CPSES-200100928
Log # TXX-01071
File # 236
May 4, 2001

SUBJECT: COMANCHE PEAK STEAM ELECTRIC STATION (CPSES)
DOCKET NOS. 50-445
REQUEST FOR ADDITIONAL INFORMATION REGARDING
STEAM GENERATOR TUBE REPAIR USING LASER WELDED
SLEEVES

SLEEVE Code Summary Report

Figure 1

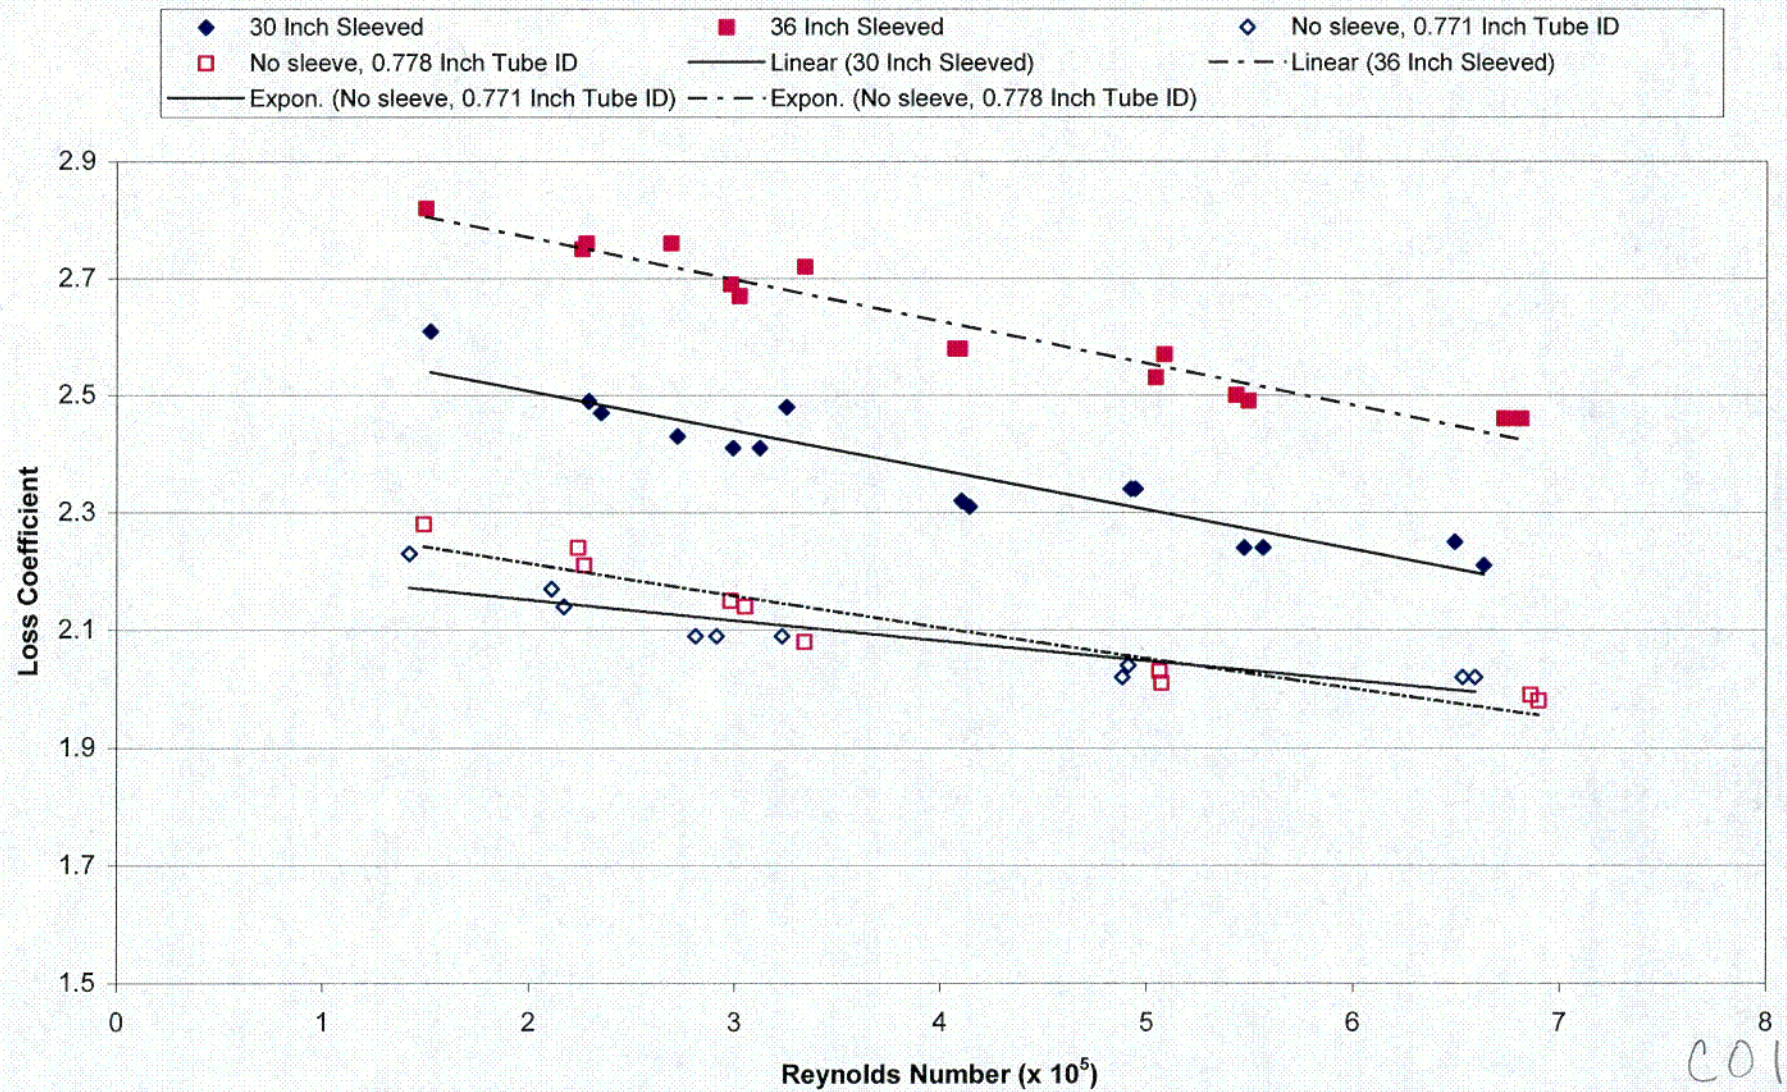
4. Laser welded sleeve/flow data from other plants.

presents a summary of the calculated loss coefficients for each case, unsleeved and sleeved, for varying Reynolds Numbers. As seen from this figure, the unsleeved case yields loss coefficients approximately equal for the 30" and 36" test setups. For these two cases, the tube ID's varied by a few mils. As would be expected, the 30" sleeved case has a lower loss coefficient than the 36" sleeved case.

For the 30" hot leg sleeve, the hydraulic equivalency determined from the test data was found to be on average 3.38 times greater than the hydraulic equivalency calculated using the SLEEVE code. For the 36" hot leg sleeve, the hydraulic equivalency was found to be on average 2.35 times greater than the hydraulic equivalency calculated using the SLEEVE code. The test data suggests that as the Reynolds Number increased, the ratio of hydraulic equivalency for test to calculated conditions indicates a slightly increasing ratio. Thus for the prototypic Reynolds Number conditions, the actual hydraulic equivalency should be larger for the actual installed condition. The variance between test and calculated hydraulic equivalencies may be due to actual installed conditions of the 30" and 36" sleeves and individual tube conditions.
